Office Action Summary	Application No. 10/630,791	Applicant(s) LIN, CHUN-WEI	
	Examiner Noah C. Hawk	Art Unit 3637

DETAILED ACTION

German Publication '657, Figure 1

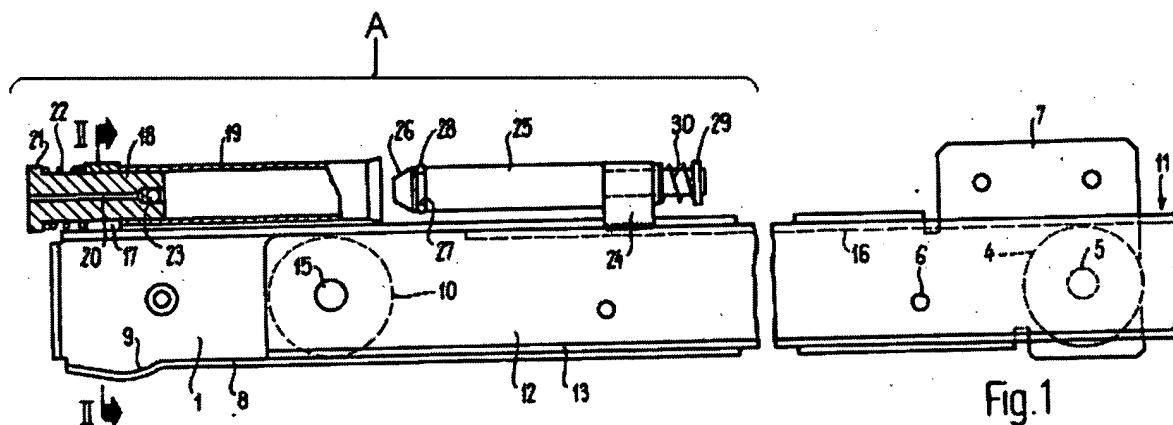
10. Claims 1, 2, 8 and 10 are rejected under 35 U.S.C. 103(a) as being unpatentable over German Patent DE 2421657 A in view of European Patent EP 1236925 A2 and further in view of Beard et al. German Publication '657 discloses a drawer slide damper mechanism (Fig 1, ref A) mounted on the edge of a drawer slide. German Publication '657 does not disclose a buffer mechanism consisting of a cylinder with an air passage in the form of a vent slot, a connecting rod with a soft piston and a valve ring or a separable bumper assembly in the form of a magnetic assembly, snap assembly or suction assembly. EP Publication '925 teaches a buffer mechanism comprising a cylinder (10) with an air passage in the form of a vent slot (40), a connecting rod (21) with a soft piston (23) and a valve ring (24) but does not teach a separable bumper assembly in the form of a magnetic assembly, snap assembly, or suction assembly. Beard et al. teach a damper with a separable, magnetic bumper assembly (36 & 37, see col. 2, lines 54-56), a hole in the wall of the cylinder (39) and an adjusting valve (41, see

Beard et al., column 3, lines 2-3). It is well known in the art that magnetic assemblies, snap assemblies and suction assemblies are equivalent releasable fastening means. It would have been obvious to one skilled in the art at the time of invention to modify the drawer slide damper assembly of German Publication '657 by using a buffer mechanism as disclosed by EP Publication '925 in order to provide a smoother damping action for the drawer slide and to further modify the device by adding a separable, magnetic bumper assembly and a hole in the cylinder wall with an adjusting valve as taught by Beard et al. in order to assist the device in returning to the open position for the next time the drawer is closed and to provide a variable damping effect.
